NRC DOCKETS 50-321, 50-366
OPERATING LICENSES DPR-57, NPF-5
EDWIN I. HATCH NUCLEAR PLANT UNITS 1, 2
ADDITIONAL INFORMATION ON INSERVICE INSPECTION
PROGRAMS RELIEF REQUEST

Response to the NRC Request
for Additional Information

Edwin I. Hatch Nuclear Plant
Unit No. 2

Figure B-1

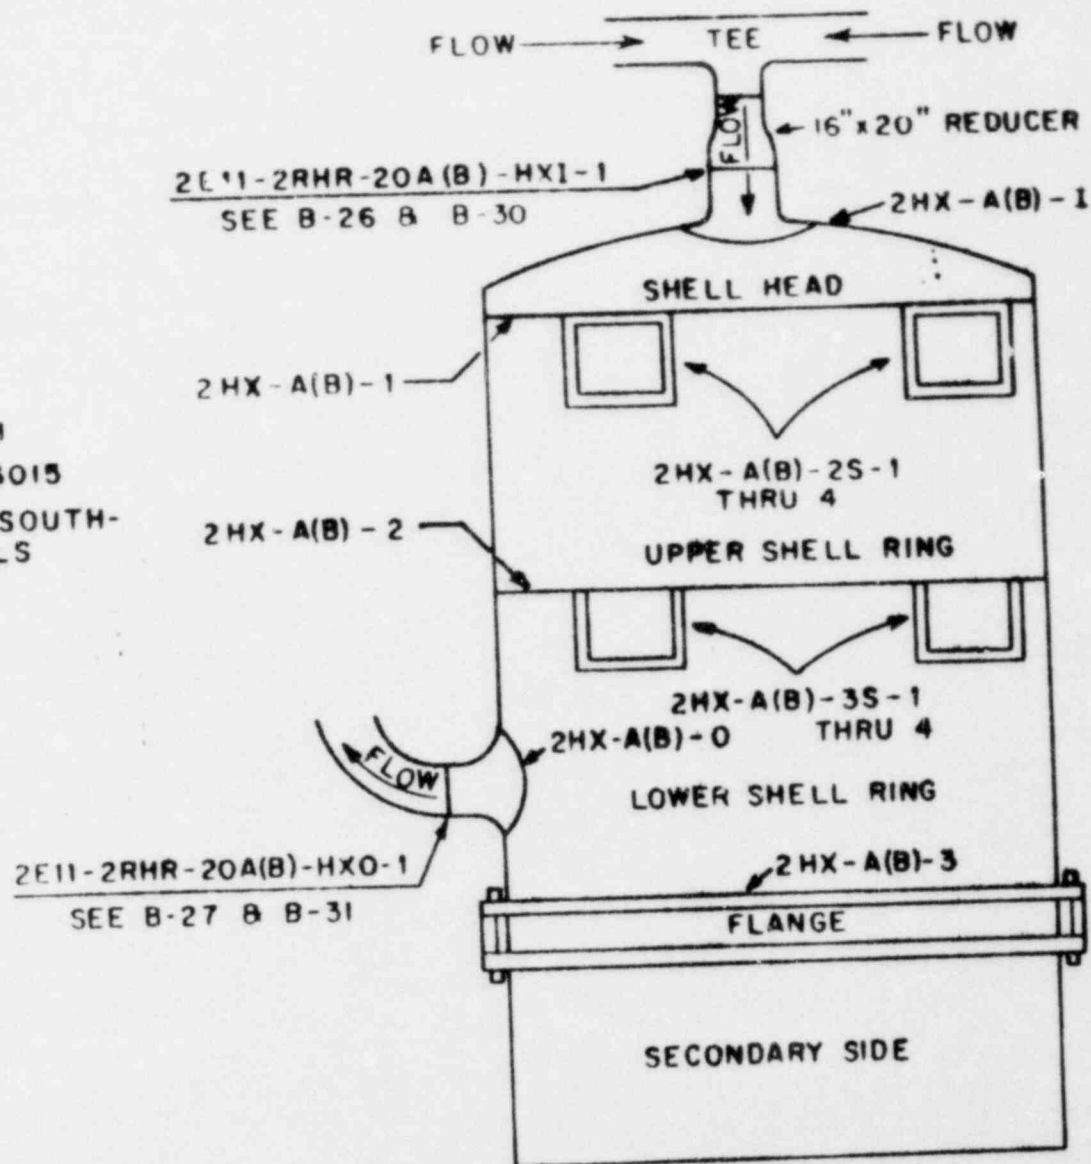
6. There are three Category C-A circumferential welds in each of the two RHR heat exchangers. These welds and their UT limitations are given below. (See attached Figure B-1).

2Hx-A(B)-1 Shell Head to Upper Shell Ring - These welds cannot be examined from the shell head side due to the curvature of the head. Only 65.2" of a total circumference of 179" (36%) can be examined from the Lower Shell Ring side due to support interference.

2Hx-A(B)-3 Lower Shell Ring to Flange - Complete coverage is obtained from the Lower Shell Ring side. Examination from the flange side cannot be performed due to the geometry.

The 1974 Edition of Section XI requires that 20% of each Category C-A weld be fully code examined; therefore, all subject welds may be fully code examined and relief is not required. However, the 1980 Edition of Section XI requires that 100% of these welds be examined. Specific relief will be requested when the program is updated (See response to Question 9).
